Monaco Coach Corp  
Roadmaster  
1809 W Hively  
Elkhart, In 46517 Fax 219-294-7322

Re: "22.5A" RVA jack system pressure increase

RVA CO.

SECTION B-B

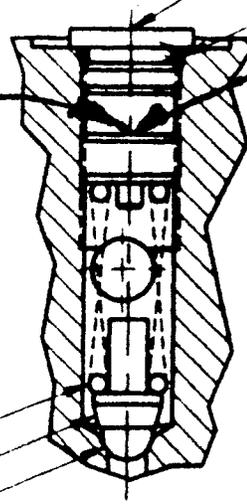
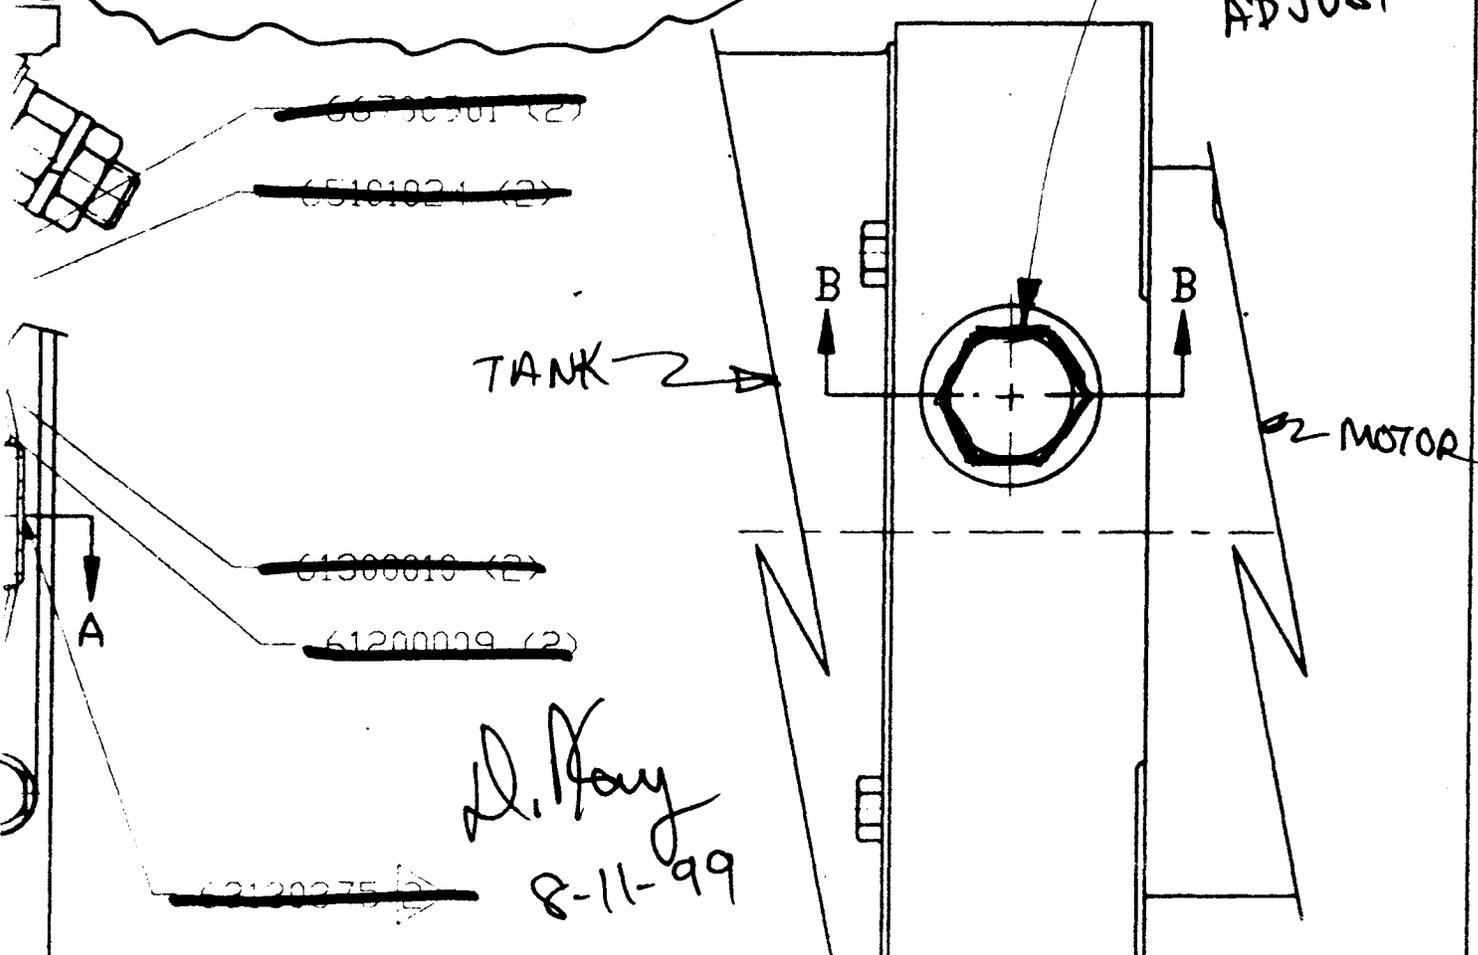
RELIEF VALVE SET @ ~~3100~~ ±50 PSI

(RATED @ 2000) 2300 ("22.5A")

1/12 TURN = APPROX. 100 PSI

URNS ON RELIEF VALVE SCREW

USING PRESSURE GAGE (0-4000 PSI) MIN, SET "22.5A" PUMP TO 2600-2800 PSI MAX

18" STROKE ON FRT JK ("22.5A") WILL EQUAL "32" FRT JK

This is a supplement to my fax of 8/11/99. Since then RVA has adjusted three "22.5A" jack system equipped 38' Diplomats. Each one was accomplished by increasing (clockwise) the pump relief valve 1/4 of a turn. This is equivalent to approximately 300 psi or 1500 more pounds of push. RVA sets the standard "22.5A" pumps at 2300 psi at our plant, while rating them at 2000 psi. At 2300 psi the equivalent push is 11,500 pounds. With the additional 1500 pounds (1/4 turn), this is equal to approximately 13,000 pounds.
